ND-2012-0023 March 29, 2012

Subject: PSEG Early Site Permit Application Docket No. 52-043 Response to Request for Additional Information, RAI No. 46, Gaseous Waste Management System

Revision 1 of Response to RAI No. 46

Part 2 – Site Safety Analysis Report (SSAR) Section 1.3 Plant Parameter Envelope

3 Table 1.3-7 (Sheet 2.012)

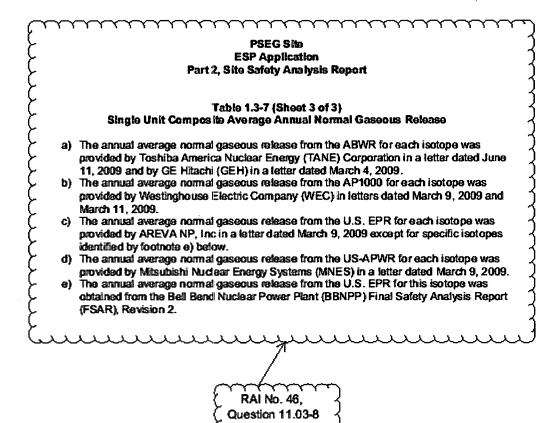
In the response to RAI 18 (eRAI 5466), Question 11.03-3, PSEG applied liquid and gaseous effluent source terms based on the Bell Bend Nuclear Power Plant's (BBNPP) Combined License Application (COLA), Final Safety Analysis Report (FSAR), Rev. 2, Section 11.3. A review of the BBNPP COLA FSAR effluent source terms indicates that the source terms are different than those described in the U.S. EPR Design Certification (DC) Application, Rev. 3. It should be noted that the BBNPP COLA has sought a departure from the U.S. EPR DC source terms, and that the BBNPP COLA application is not the reference COLA for this reactor design. In addition, the applicant should be aware that the staff has issued specific RAIs on BBNPP's approach and justification in developing liquid and gaseous alternate source terms. As a result, the applicant is requested to:

- 1. Confirm whether the applicant intends to apply the effluent source terms proposed in the BBNPP COLA application as opposed to using those of the U.S. EPR DC Application, Rev. 3. If not, the applicant should revise the ESP effluent and dose analyses using the source terms from the U.S. EPR Design Certification, Rev. 3, Sections 11.2 and 11.3. If the applicant intends to apply the effluent source terms from the BBNPP COLA application, provide clarification for using these source terms.
- 2. Review and verify the other source terms being utilized in the ESP application and document what revisions are currently being used for each of the designs.

The correspondence received from the reactor technology vendors will be made available for NRC staff review. SSAR Table 1.3-7 will be revised to add footnotes identifying the source of the information on the annual average normal gaseous release for each isotope. There is no intention to update the information in the PSEG Site ESP application if the reactor technology vendor's information on the annual average normal gaseous release for each isotope is revised. When PSEG selects a reactor technology and submits a Combined License (COL) application, the ESP PPE values will be the focus for comparison with the design of the actual plant proposed for the site.

Footnotes added in response to RAI No. 46, Question 11.03-8

Footnotes added in response to RAI No. 46, Question 11.03-8
